1999 Legend PDI Information

Most of the features, equipment, and delivery preparation procedures for the 1999 Legend are the same as for previous models. This service bulletin describes those things that are unique to the 1999 model.

LARGER BRAKES

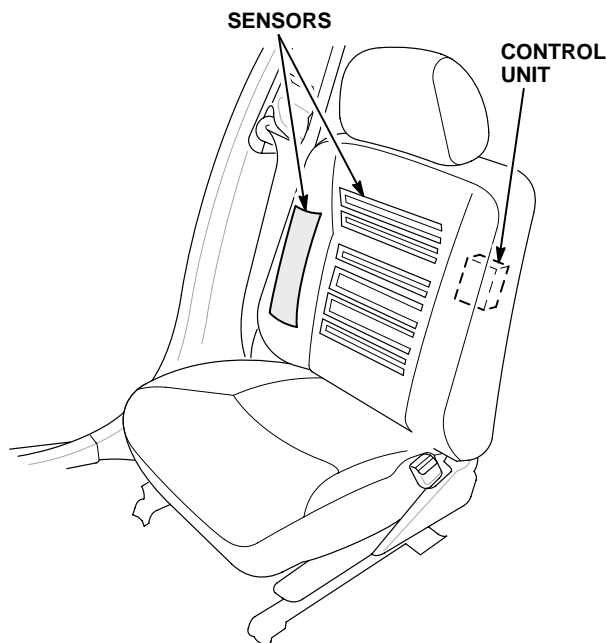
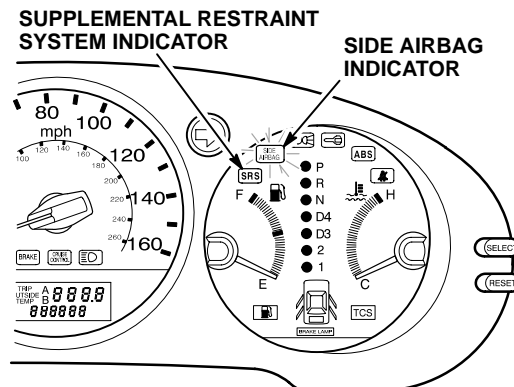
The 1999 Legend has 300 mm front brake discs; they are 18 mm larger than those on the 1996–98 Legend. Earlier Legend wheels, including the optional steel wheels used for snow tires, do not fit on the '99 model.

READING SRS DTCs

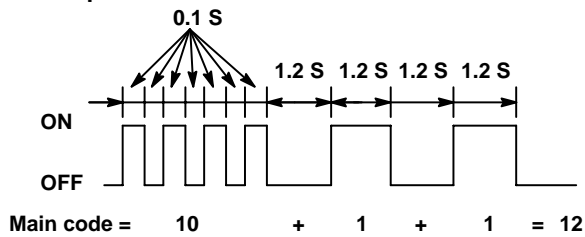
Additional SRS codes have been added for the side airbag system, and the SRS light indicates these codes differently. For example, the "10" in codes 11 through 14 is indicated by four short blinks. Refer to the 1999 Legend Shop Manual Supplement for more information.

HIGH INTENSITY DISCHARGE (HID) HEADLIGHTS

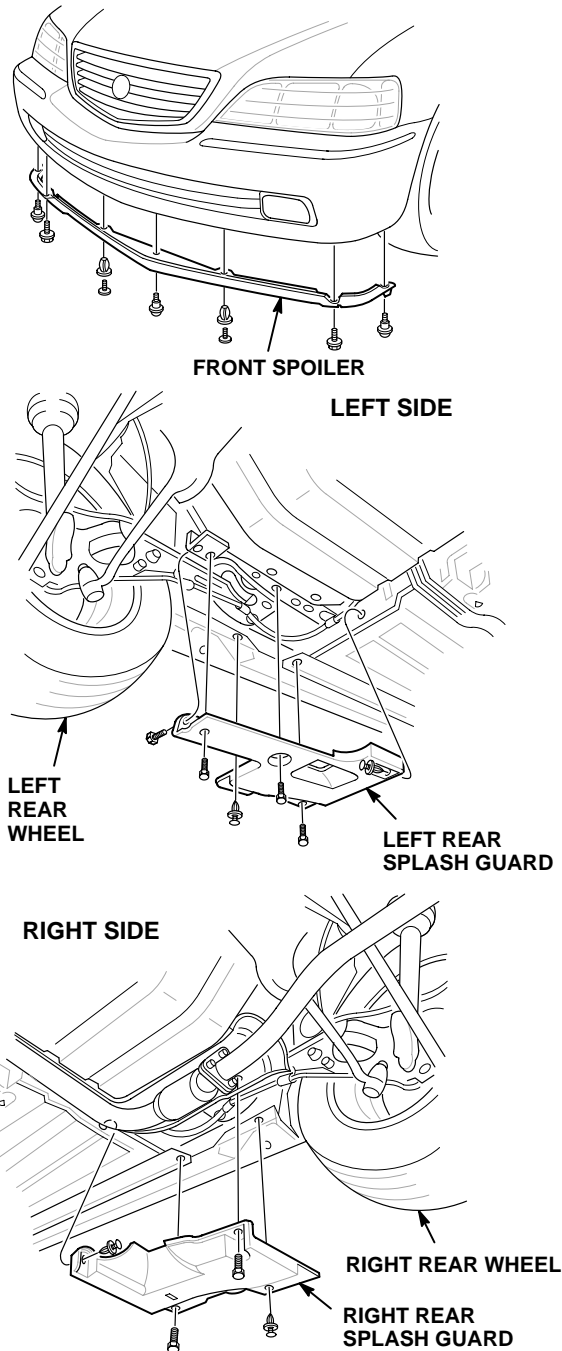
The new low-beam headlight is a discharge type. It uses high voltage at start-up, and it requires special attention during servicing. Do not check the bulb operation outside of the headlight assembly.
